# UNITED STATES PATENT AND TRADEMARK OFFICE

| APPLICATION NO. | FILING DATE | FIRST NAMED INVENTOR | ATTORNEY DOCKET NO. | CONFIRMATION NO. |
|-----------------|-------------|----------------------|---------------------|------------------|
| 10/803,582      | 03/17/2004  | Chiyoshi Sasaki      | KAW-0049            | 6139             |

**Office Action Summary**

Fig 1

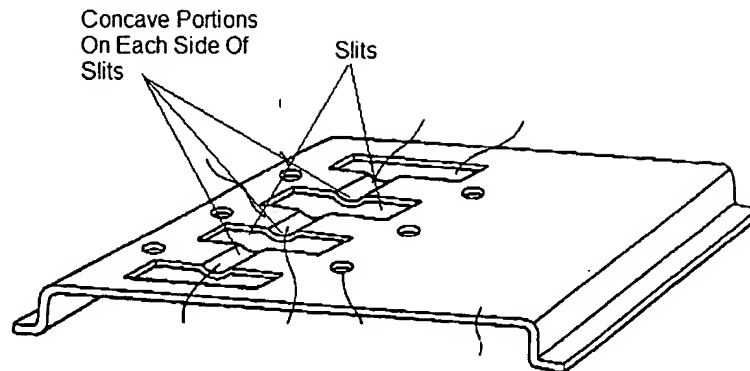
With respect to the Applicant's remarks to claim 9 that, "Sasaki does not teach any concave portions on the sides of slits", the Examiner respectfully disagrees. The Applicant is directed to present office action Fig 1 below which clearly discloses that the Sasaki reference teaches concave portions on the sides of slits as claimed.
